Amendments to the Drawings:

REMARKS/ARGUMENTS

Appl. No. 10/695,881 Amendment dated May 2, 2006 Reply to Office Action dated Feb. 2, 2006

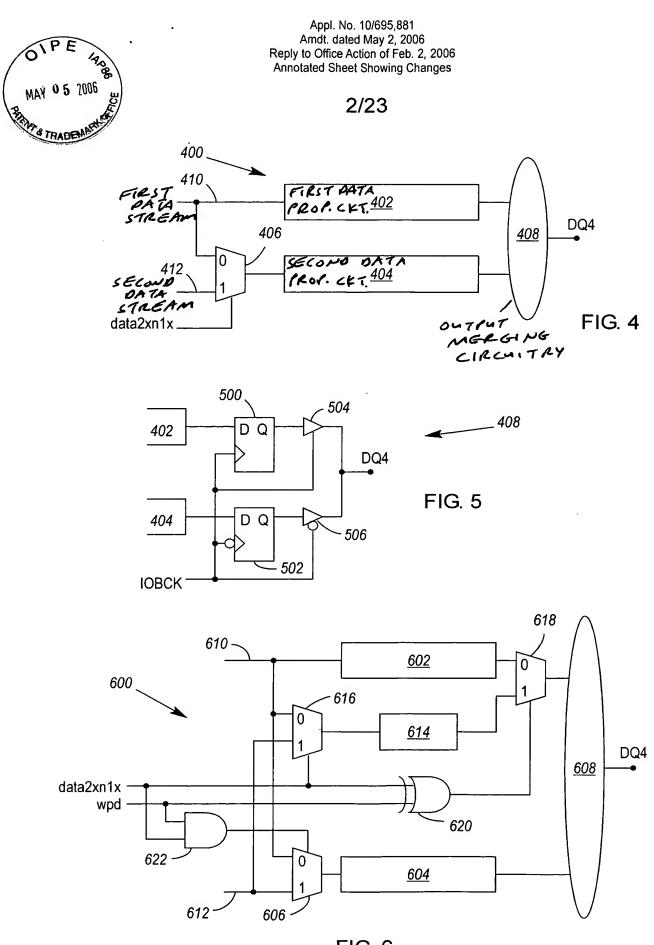
The drawings are objected to because in Fig 4, add label for Refs, 402, 404, 406, 408, 410, and 412 for --first propagation--, --second propagation--, --multiplexing stage--, --output merging--, --first data stream--, and --second data stream-- to facilitate the general understanding of the present invention for clarity.

The attached sheet of drawings includes changes to FIG. 4. This sheet, which includes FIGS. 4-6, replaces the original sheet including FIGS. 4-6. In FIG. 4, text labels have been added to the boxes illustrated therein.

Although applicants believe that figures are generally most appropriately labeled with reference numbers, and that FIG. 4 is so labeled, applicants have amended FIG. 4 to add all of the Examiner's labels, but for the label identifying a "multiplexing stage", which label is believed to be redundant given that the shape of object 406 clearly signifies a multiplexer. The amendments to FIG. 4 are not believed to add new matter.
